Block 1/4GFA (incl. Brewery)
Approved CP: 66,910m2
Amended CP: 77,000m2
Change: +10,090m2
Block 1 - Height
Approved CP: +70.80m (AHD)
Amended CP: +79.50m (AHD)
Change: +8.70m
Block 2 - Height
Approved CP: +133.00m (AHD)
Amended CP: +133.20m (AHD)
Change: +0.20m
Block 2 - GFA
Approved CP: 45,094m2
Amended CP: 68,000m2
Change: +22,906m2
Block 3 - Height
Approved CP: +45.70m (AHD)
Amended CP: +45.60m (AHD)
Change: -0.10m
Block 3 - GFA
Approved CP: 9,953m2
Amended CP: 10,500m2
Change: +547m2
Block 6 - Height
Approved CP: +34.60m (AHD)
Amended CP: +38.85m (AHD)
Change: +4.25m
Block 6 - GFA
Approved CP: 1,892m2
Amended CP: 2,550m2
Change: +658m2
Block 7 - Height
Approved CP: N/A
Amended CP: +29.60m (AHD)
Block 7 - GFA
Approved CP: N/A
Amended CP: 1,250m2
Block 4 - Height
Approved CP: +62.50m (AHD)
Amended CP: +79.50m (AHD)
Change: +17.00m
Block 5 - Height
Approved CP: +110.70m (AHD)
Amended CP: +81.90m (AHD)
Change: -35.80m
Block 5 - GFA

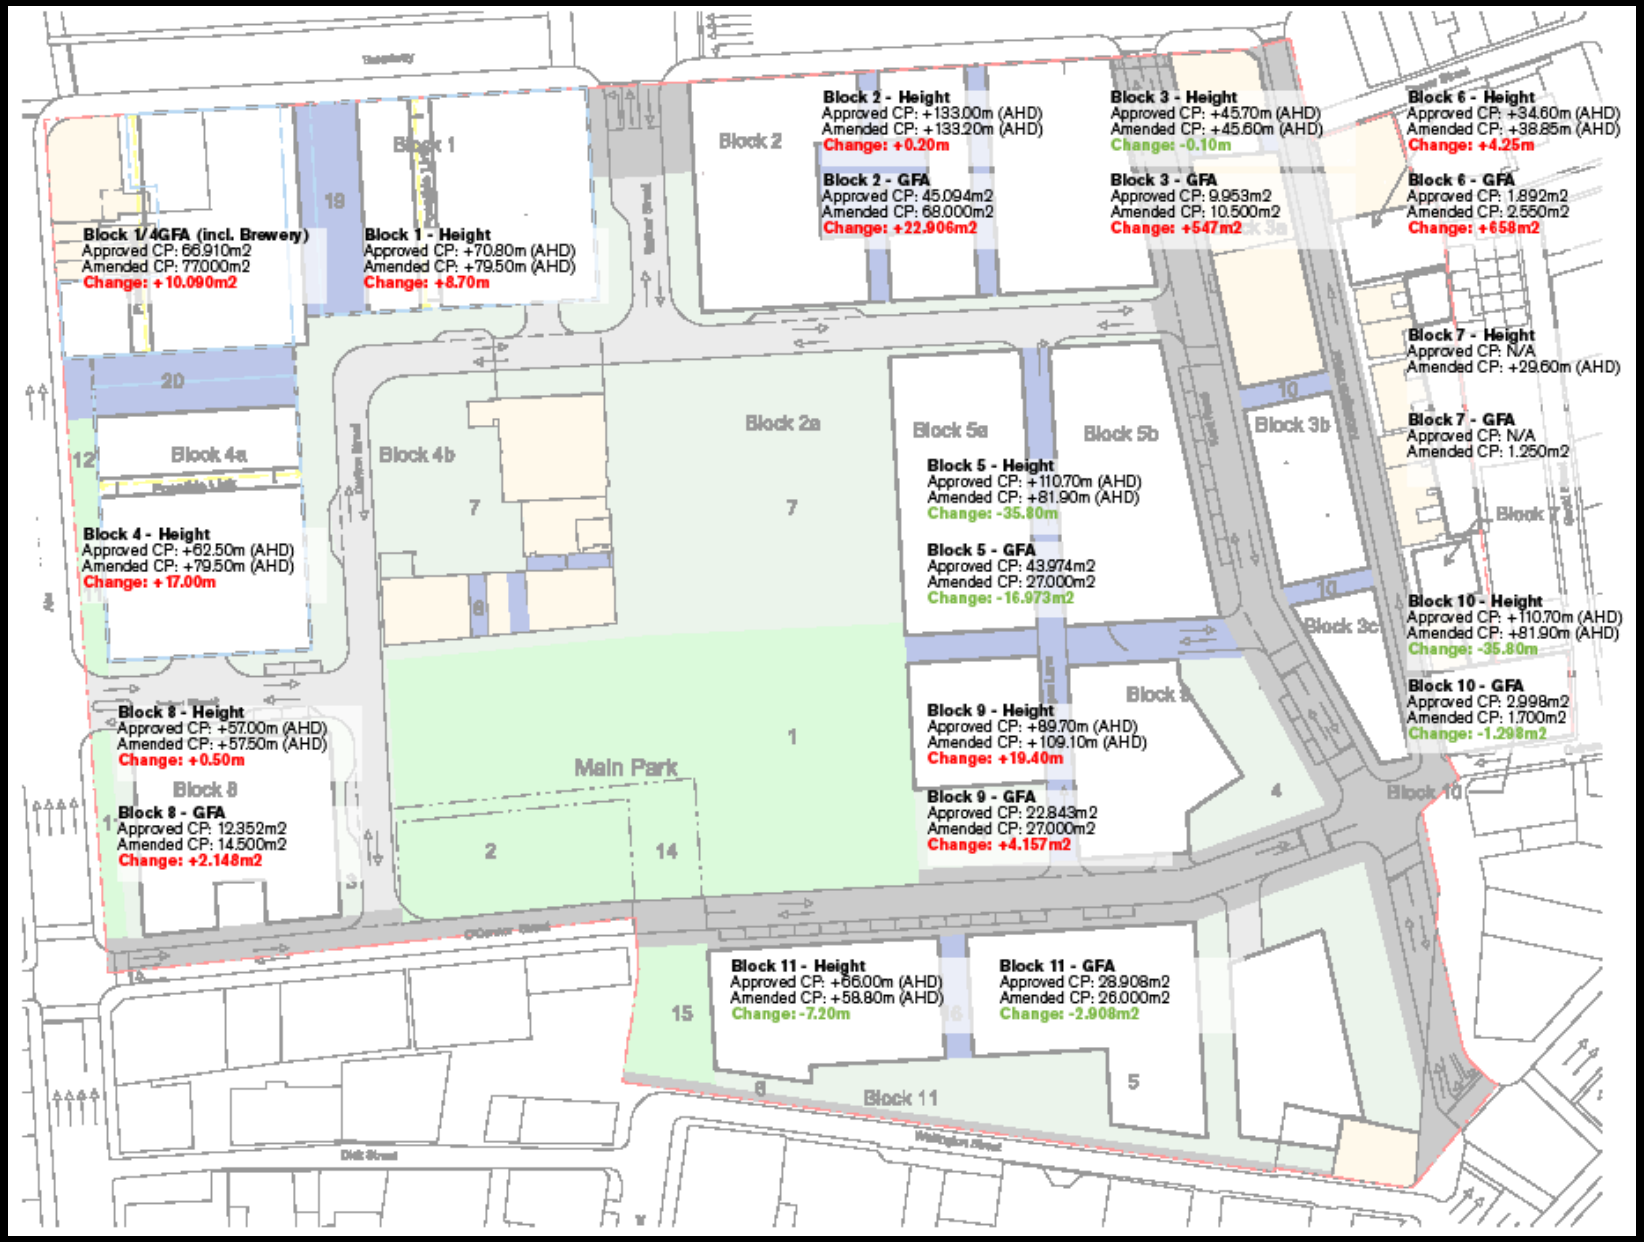
Approved CP: 43,974m2
Amended CP: 27,000m2
Change: -16,973m2
Block 10 - Height
Approved CP: +110.70m (AHD)
Amended CP: +81.90m (AHD)
Change: -35.80m
Block 10 - GFA
Approved CP: 2,998m2
Amended CP: 1,700m2
Change: -1,298m2
Block 8 - Height
Approved CP: +57.00m (AHD)
Amended CP: +57.50m (AHD)
Change: +0.50m
Block 8 - GFA
Approved CP: 12,352m2
Amended CP: 14,500m2
Change: +2,148m2
Block 9 - Height
Approved CP: +89.70m (AHD)
Amended CP: +109.10m (AHD)
Change: +19.40m
Block 9 - GFA
Approved CP: 22,843m2
Amended CP: 27,000m2
Change: +4,157m2
Block 11 - Height
Approved CP: +66.00m (AHD)
Amended CP: +58.80m (AHD)
Change: -7.20m
Block 11 - GFA
Approved CP: 28,908m2
Amended CP: 26,000m2
Change: -2,908m2
Block 1
Block 2
Block 2a
Block 3b
Block 3c
Block 4a
Block 4b
Block 5a
Block 5b
Block 8
Block 9
Block 10
Block 11
Main Park
Chapel Street
Dock Street
Wellington Street
